# PTS Consistency Effort

## **Problem Statement:**

# Consistency Effort Data Sheet

Beaver Valley Case 009 (black) –vs– Oconee Case 156 (red) –vs– Palisades Case 040 (green)

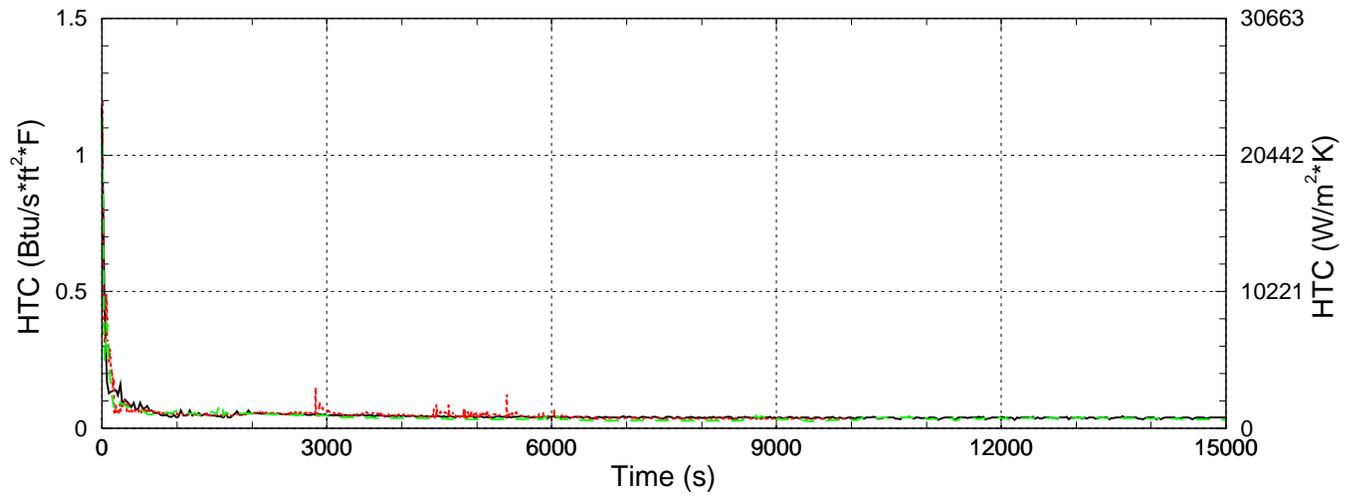
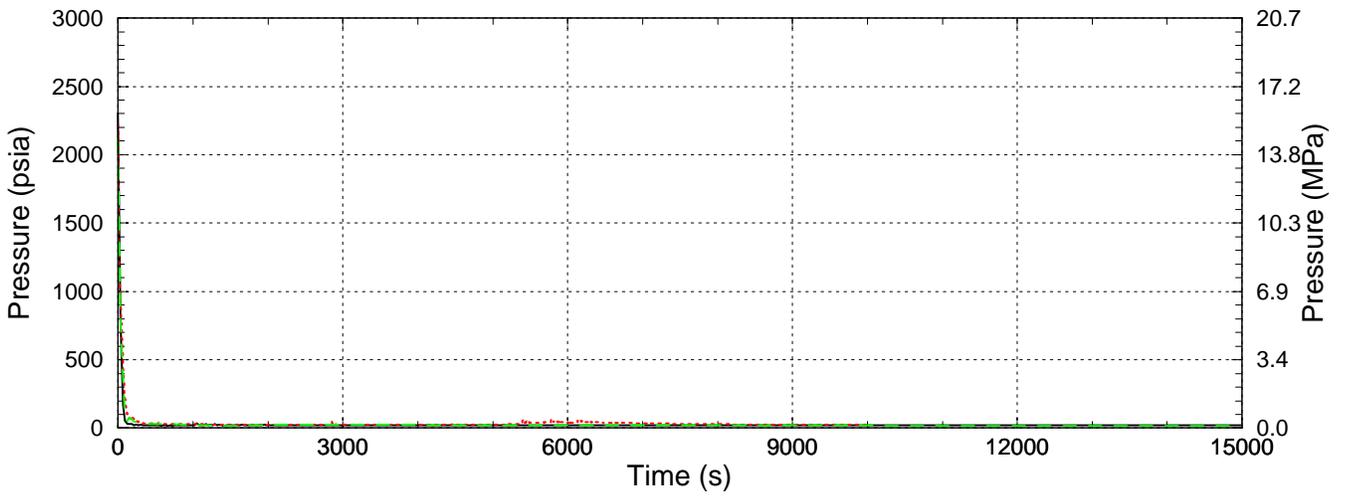
Beaver Valley cools down slightly faster than Palisades and Oconee. Beaver Valley has colder injection water as it is cooled all year long. Oconee has a slightly slower cool down due to vent values in the downcomer.

Beaver Valley temperature slope is slightly different from 0-1000s due to throttling of high pressure injection (HPI).

All three plants have temperature increases between 1000s and 2000s as the injection flow switches to the containment sump which supplies much warmer water.

Beaver Valley Case 007 (black) –vs– Oconee Case 164 (red) –vs– Palisades Case 062 (green)

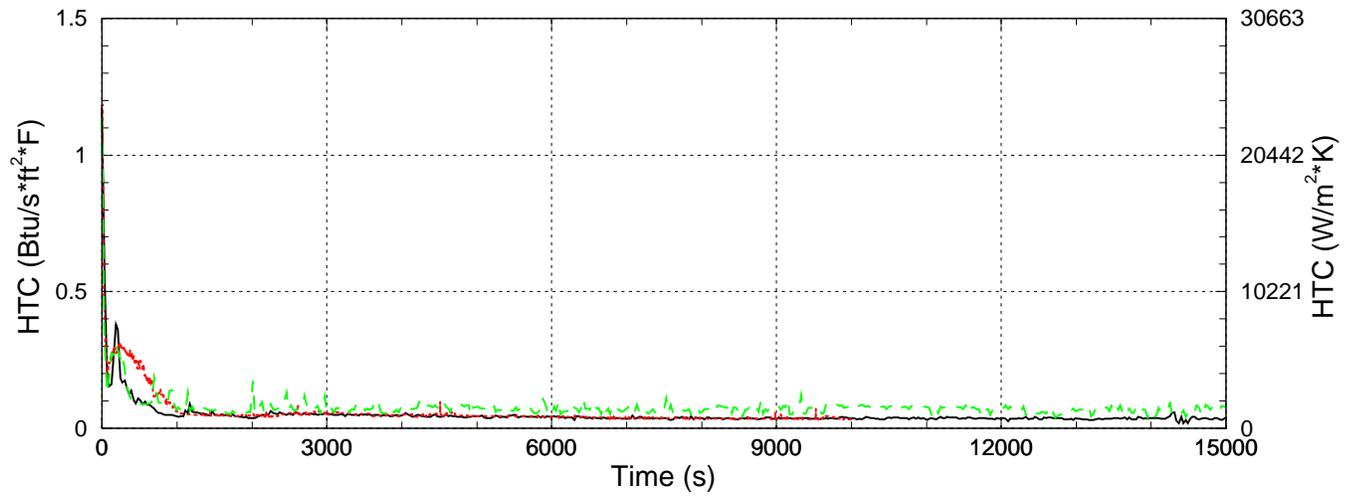
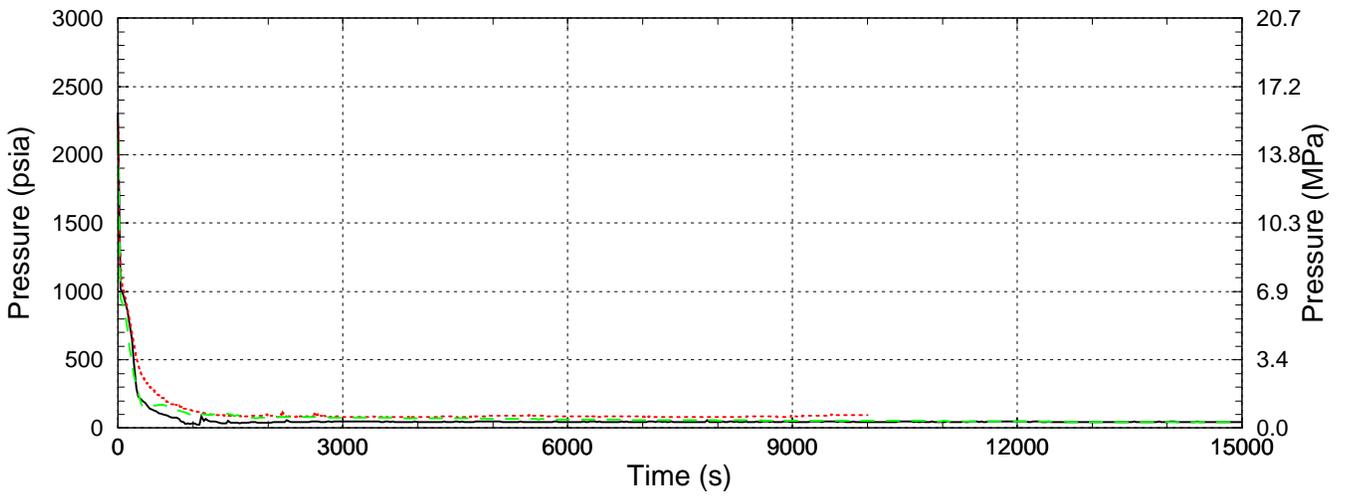
Since Palisades Break is on the cold leg, some of the ECCS water will go out the break versus into the downcomer; therefore temperature is not expected to drop as low as the other plants.

Recirculation Actuation Signal (RAS) occurs between 1000s and 2000s causing an increase in temperature. Oconee temperature drop is not as quick due to the vent valves in the vessel. Palisades low pressure injection (LPI) pumps stop on RAS therefore the final temperature is higher due to lower injection flow into the system.

Beaver Valley Case 056 (black) –vs– Oconee Case 172 (red) –vs– Palisades Case 058 (green)

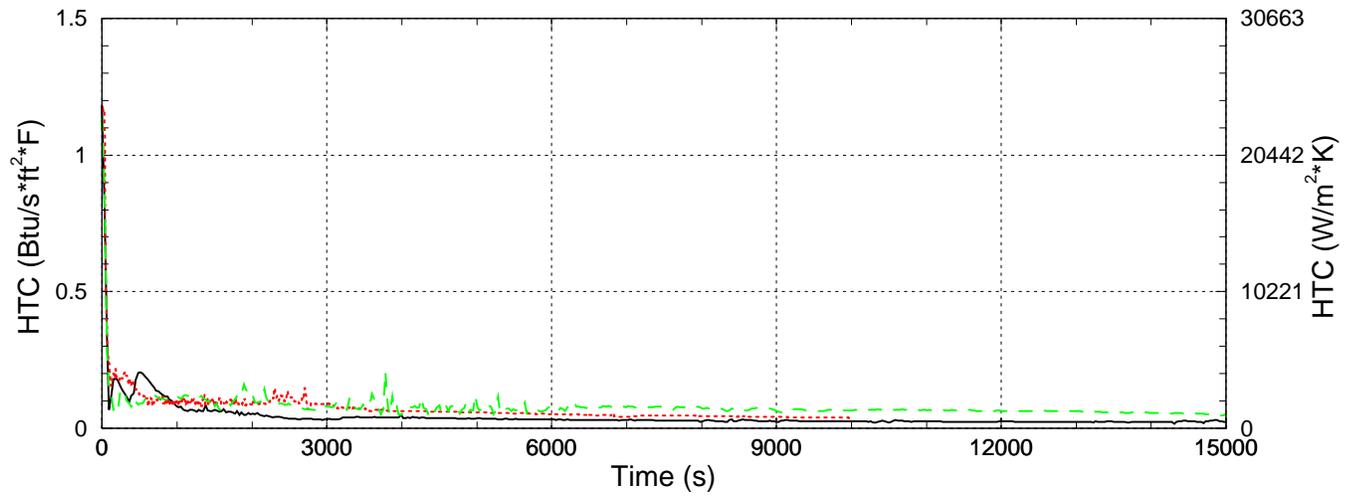
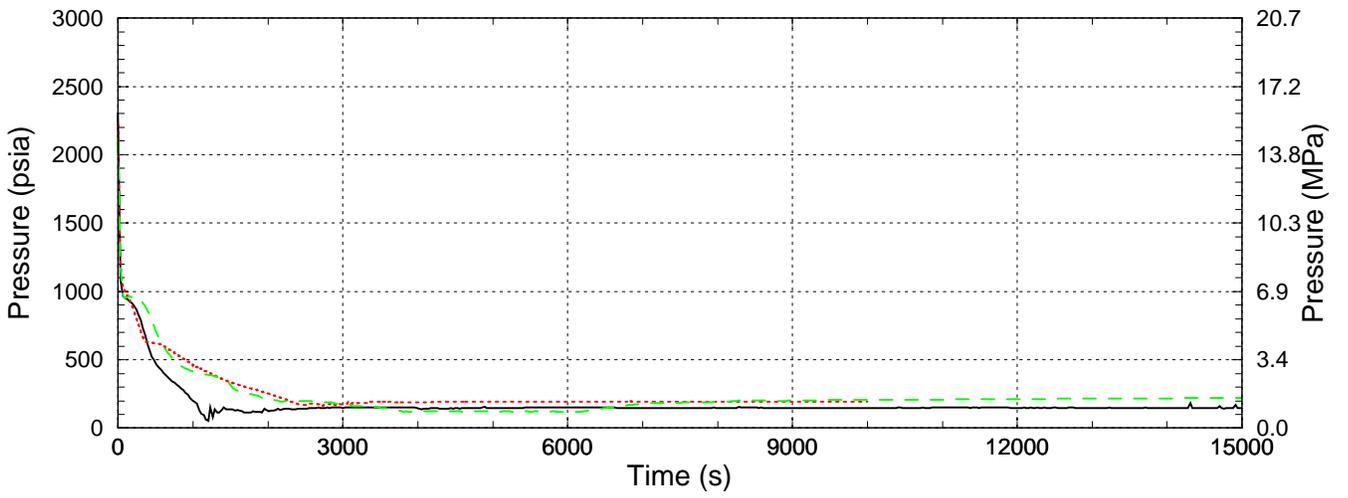
Beaver Valley cool down should be quickened due to low heat load in core.  
RAS occurs after 3000s.  
Temperature of Oconee will decrease slower due vent valves.

Following RAS palisades, temperature higher due to LPI secured  
Temperature increase in Palisades, at 1500s is due to backflow out of the cold leg break,  
Oconee rate of temperature decrease at 2000s due to LPI.

Beaver Valley Case 003 (black) –vs– Oconee Case 110 (red) –vs– Palisades Case 060 (green)

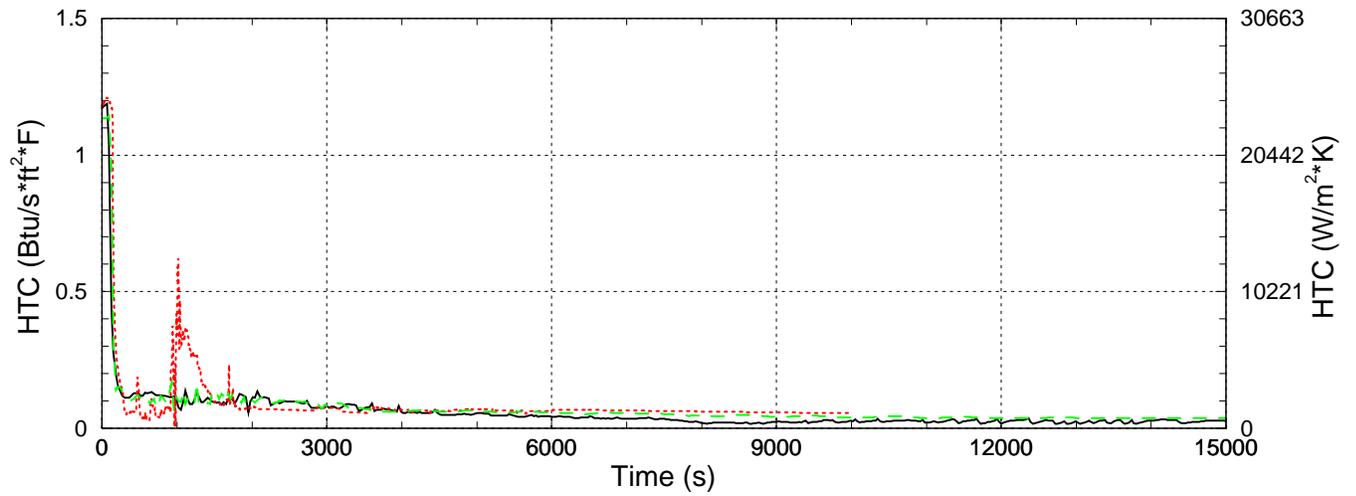
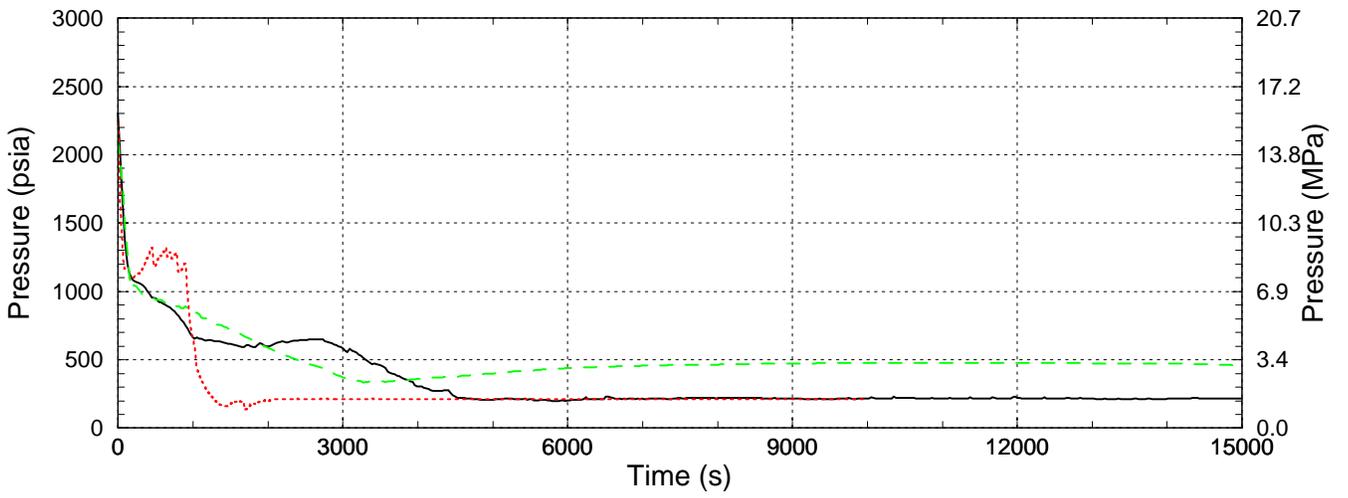
With HPI failure at Oconee, pressure and temperature should not track Beaver Valley and Palisades.

Beaver Valley & Palisades temperature and pressure track very well. The 2 spikes in temperature at 2000s are due to the throttling of HPI.

Beaver Valley Case 102 (black) -vs- Palisades Case 024 (red)

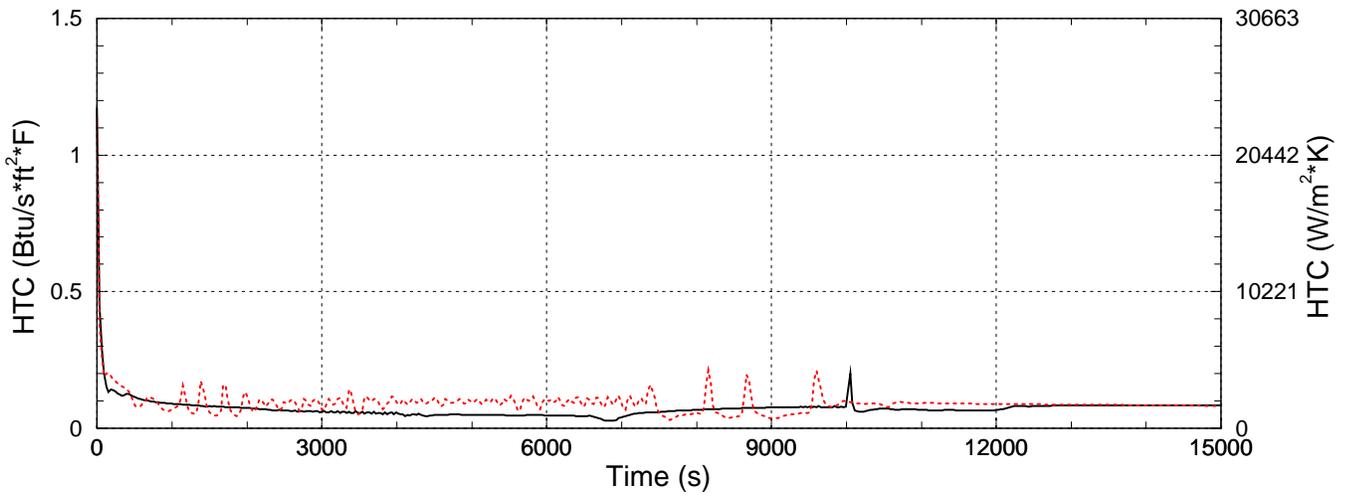
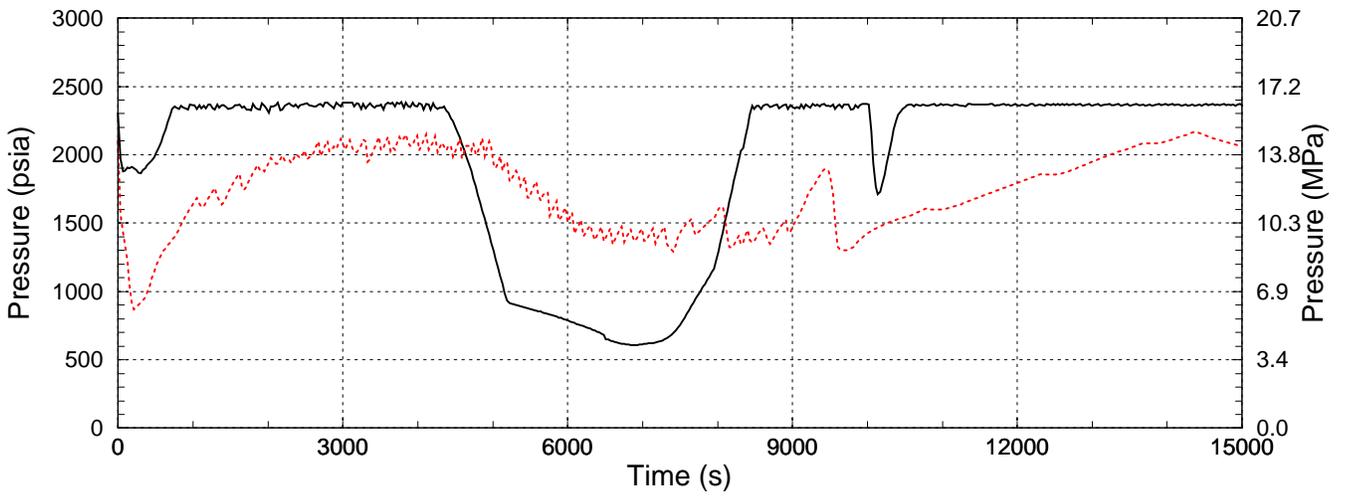
These events are similar. Pressure control by HPI – Palisades' shutoff head 1250 psi, Beaver Valley has high head pumps.

Initially Temperature drops consistent, until Palisades HPI reaches shut off head, then only charging pumps therefore temperature is higher (lower flow) and pressure increase is slower.

Beaver Valley Case 118 (black) –vs– Beaver Valley Case 112 (red) –vs– Beaver Valley Case 110 (green)

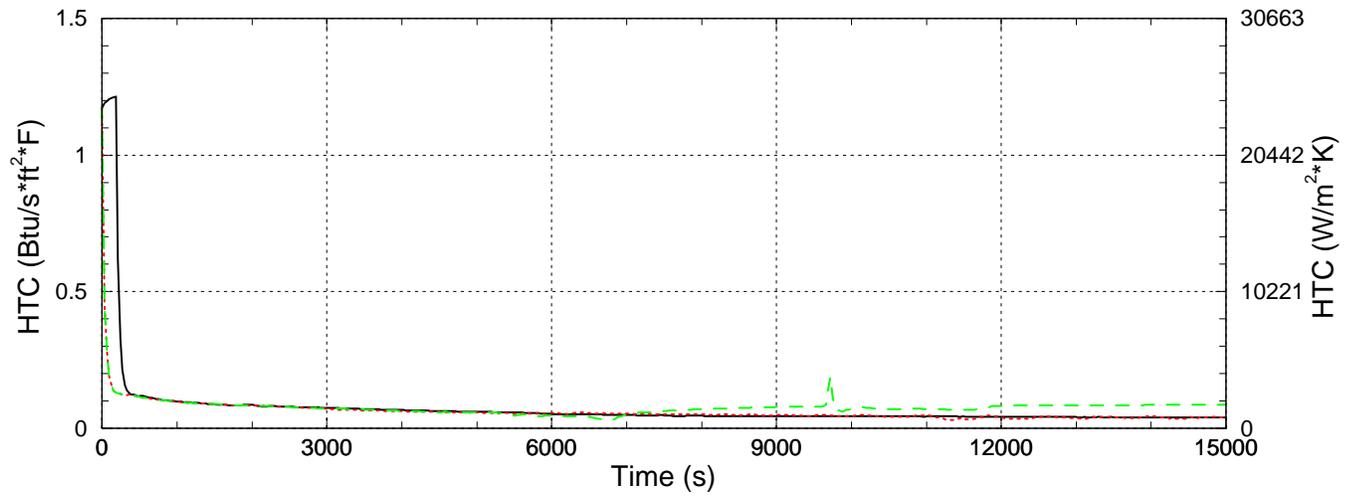
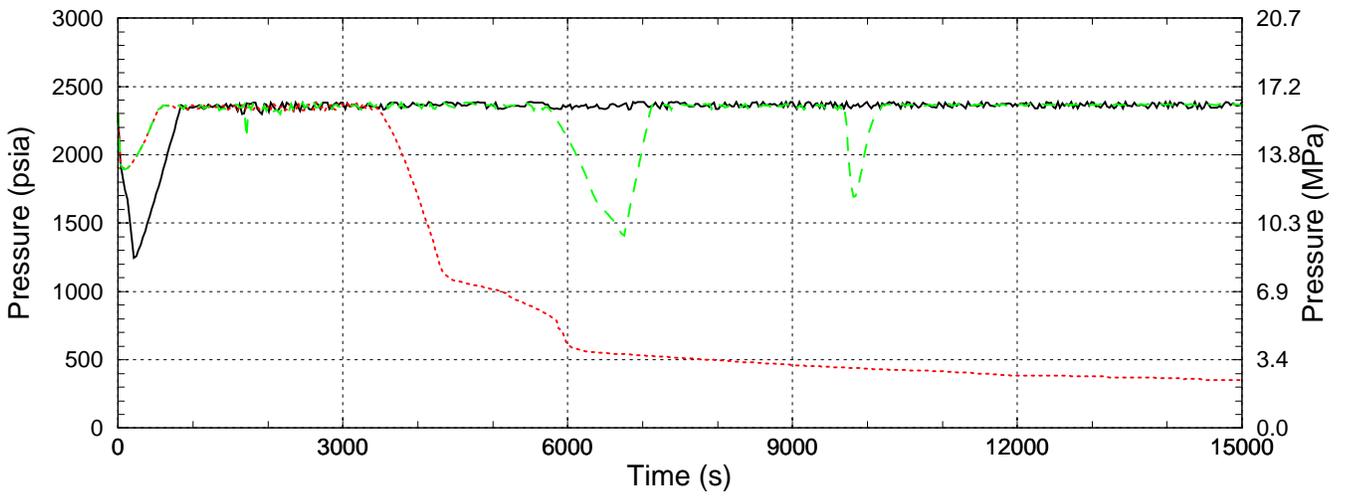
RCP's are tripped when criteria in procedures is met for case 118.

Except for effect of RCP's graphs track very well. For case 110 HPI is secured 1000s after throttling, this results in pressure and temperature increase.

Beaver Valley Case 102 (black) -vs- Beaver Valley Case 104 (red)

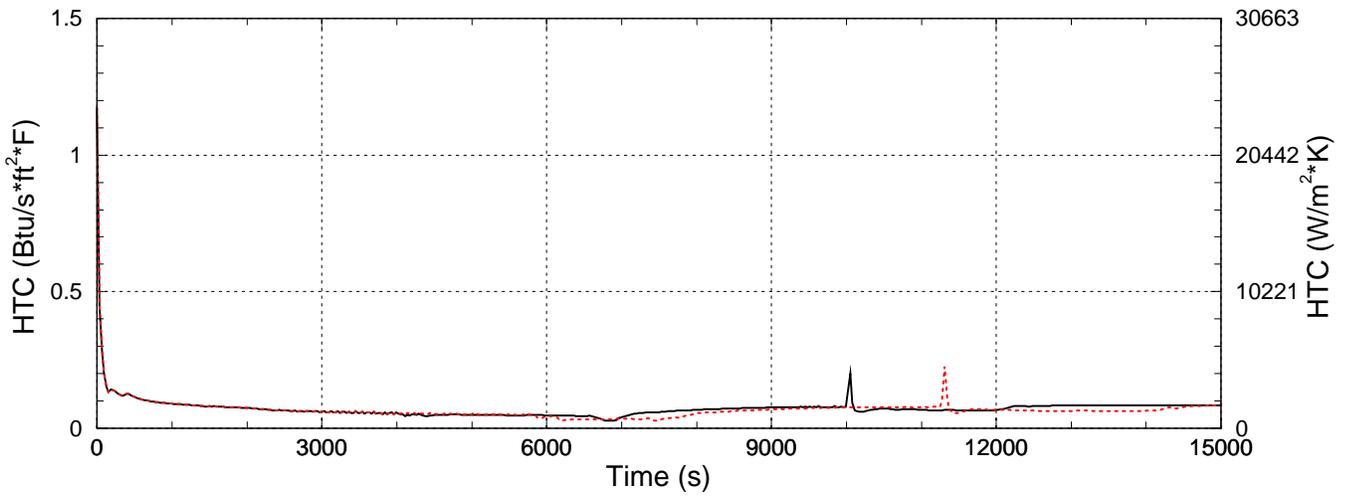
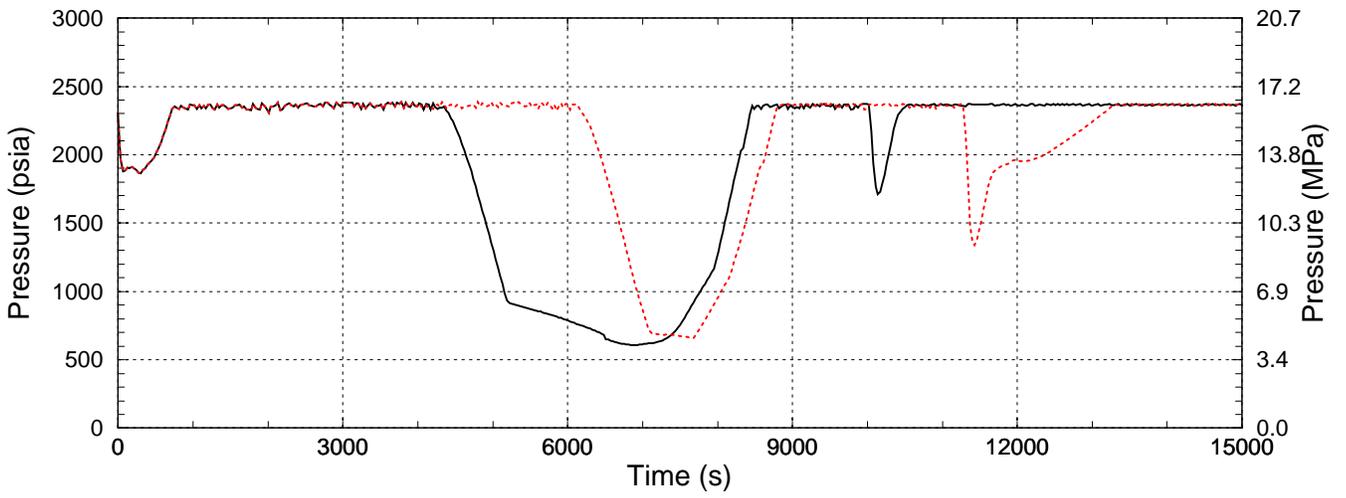
Graphs should trend well, with pressure decrease at HPI throttling time

Graphs trend well, until throttling criteria is no longer met, then pressure and temperature increase

Beaver Valley Case 060 (black) –vs– Beaver Valley Case 095 (red) –vs– Beaver Valley Case 096 (green)

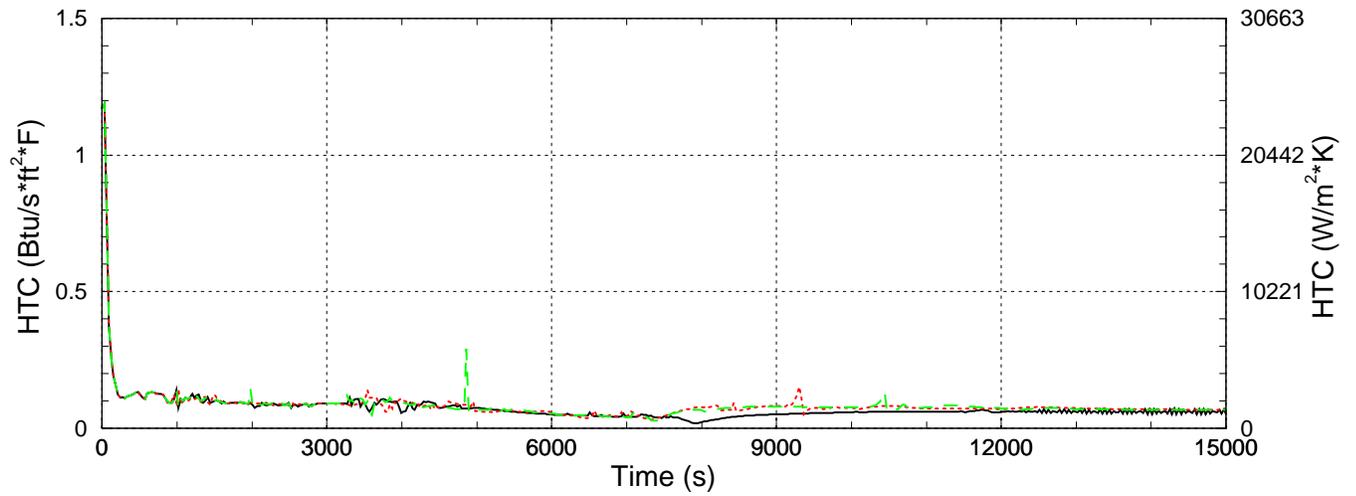
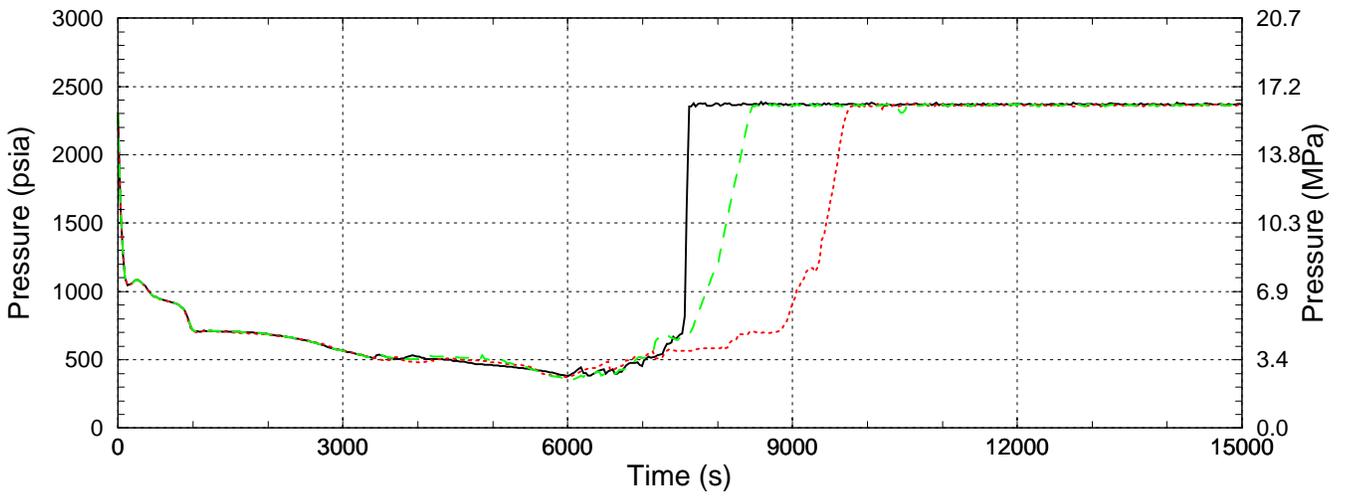
When the valve re-closes at 3000s, if no HPI throttling has occurred, pressure will increase quickly. If throttling occurs, then pressure should be controlled. Case 59 is a HFP case and temperature will not decrease as fast or as far due to the hot condition in the core. When throttling occurs, temperature will increase due to the decreased amount of flow into the RCS.

As expected, except for the HPI throttling 10 minutes after allowed. In this case, the throttling occurred too late to prevent re-pressurization. However once throttling occurred, pressure came down as expected.
